PUBLIC INTEREST REVIEW FOR GROUNDWATER APPLICATIONS

SUBJECT: Application G- **18155** Supersedes review of _____
Date of Review(s)

A. GENERAL INFORMATION: Applicant's Name: **Robert Blake III** County: **Deschutes**

A1. Applicant(s) seek(s) **0.0125** cfs from **1** well(s) in the **Deschutes** Basin, **Upper Deschutes** subbasin

Water-Level Trends in Nearby Wells

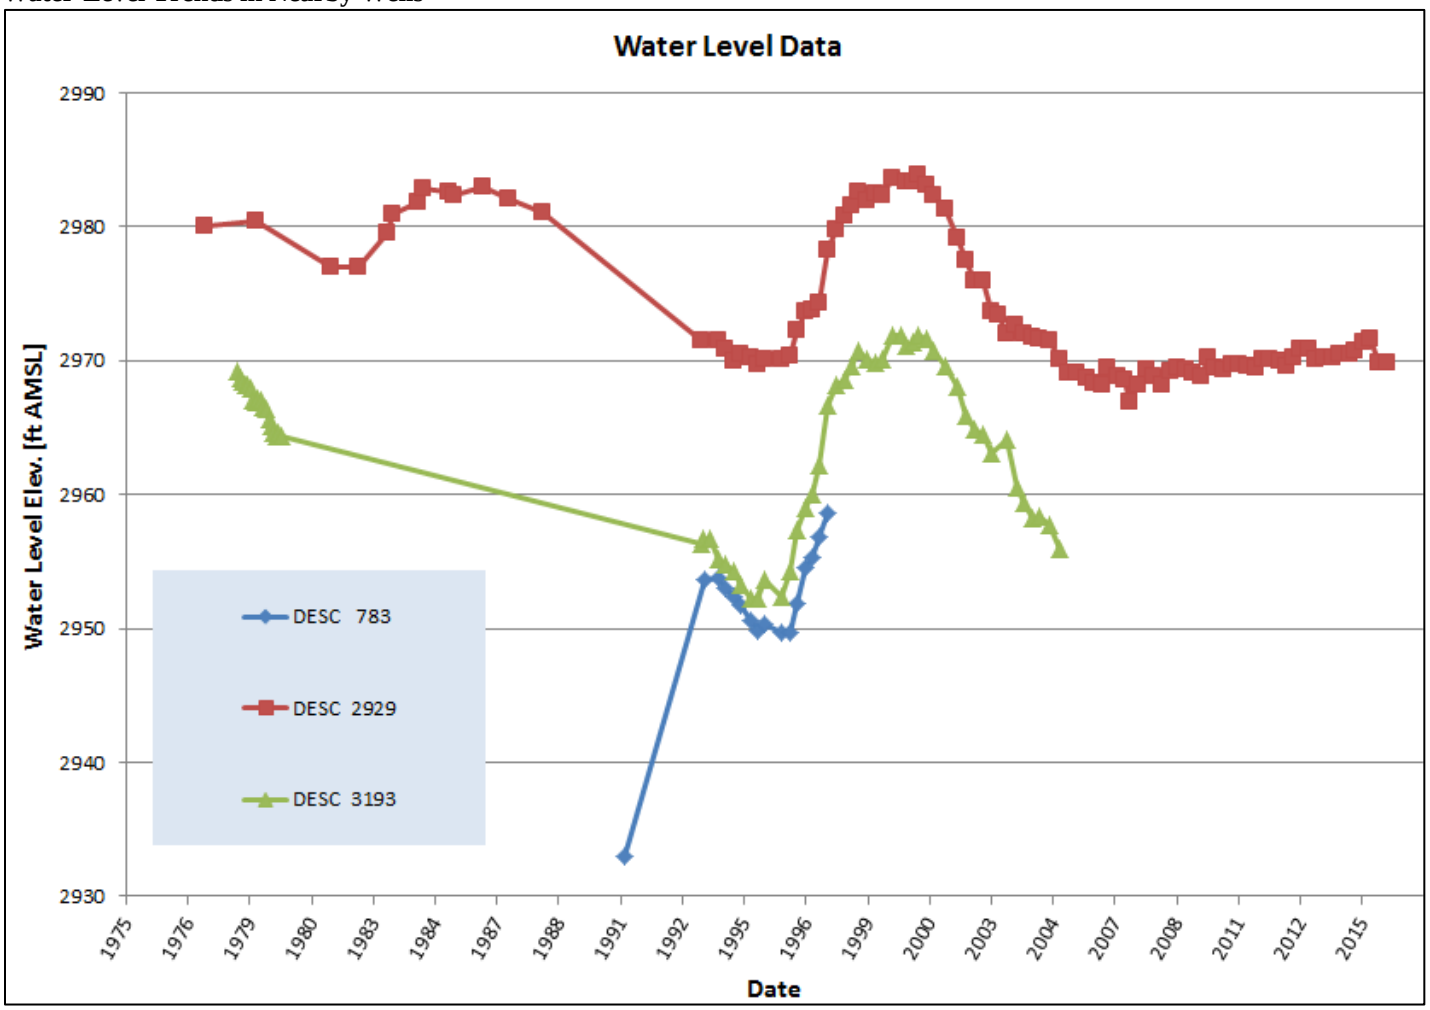
The nearest State Observation Well (DESC 3193) is located approximately 1.7 miles to the northwest, unfortunately measurements at this well ceased in 2005. The nearest State Observation Well currently being measured (DESC 2929) is located approximately 6 miles to the northwest. Some measurements exist for a domestic well (DESC 783) located approximately 1.7 miles to the east. During the periods of overlap, the hydrograph of all three wells shows a similar pattern. Historically, the wells appear to have been in dynamic equilibrium. The long-term trends show a decadal-scale water level fluctuation that is coincident with climate cycles. The decadal fluctuation has a maximum amplitude of approximately 15 feet. Since 2000, the water level has dropped about 15 feet, with a slight increase since 2005. The decline is likely mostly due to decreased recharge. However, since 2006 water level trends in DESC 2929 have deviated from climate cycle trends. The divergence from climate driven water level trends in DESC 2929 is likely due to decreased canal leakage and increased local groundwater pumping.
